PUBLIC INTEREST REVIEW FOR GROUNDWATER APPLICATIONS

TO: Water Rights Section Date August 12, 2015
 FROM: Groundwater Section Aurora C. Bouchier
 SUBJECT: Application G- 18076 Reviewer's Name Supersedes review of na
 Date of Review(s) _____

A. GENERAL INFORMATION: Applicant's Name: Meza County: Clackamas

Stream Depletion Results

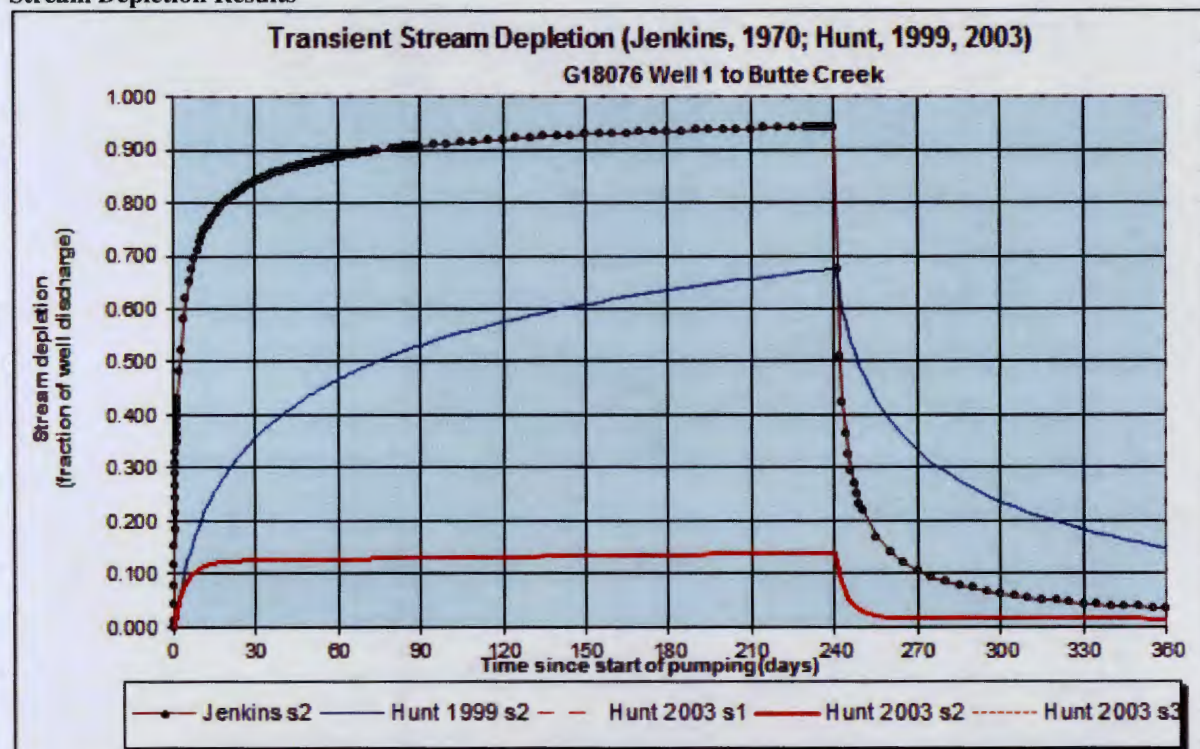
Comments: Stream depletion was estimated using the Hunt 2003 model (see attached results). An aquifer saturated thickness value of 40 feet was used based upon published maps (Gannet and Caldwell, 1998). Butte Creek cuts through the Willamette Silt in this region. Therefore, stream clogging was modeled by using an aquitard thickness below stream value of 3 feet.
